PRODUCT ADVISORY

Data Sheet Specification Change for Intersil Product ISL5960*

**Refer to:
PA10121**

Subject: **Data Sheet Specification Change for Intersil Product ISL5960***

PA10121 – Typical Application

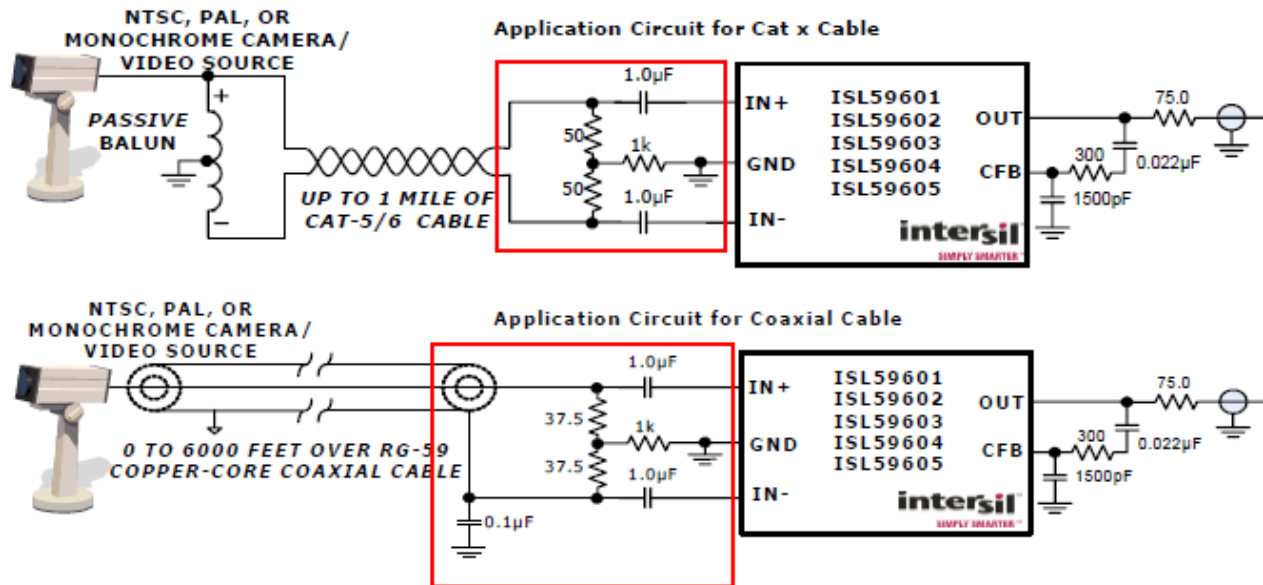
- i) The *Register Listing* has been updated to correct the bit assignments for Register 4. The bits were swapped for each function in the previous revision of the data sheet. Examples of the correct and incorrect bit assignments for Register 4 are included for reference.
- ii) The configuration of the recommended termination network for the Cat X and coaxial cables has been updated throughout the data sheet. Examples of the new and old termination network for the Typical Application are included for reference. While any designs based on the old network will continue to work, the new network provides significantly better performance for coaxial cables. The new termination can also be implemented on a board designed for the old termination simply by changing values of and/or not installing the appropriate resistors and capacitors.

New – Termination Network

Old – Termination Network
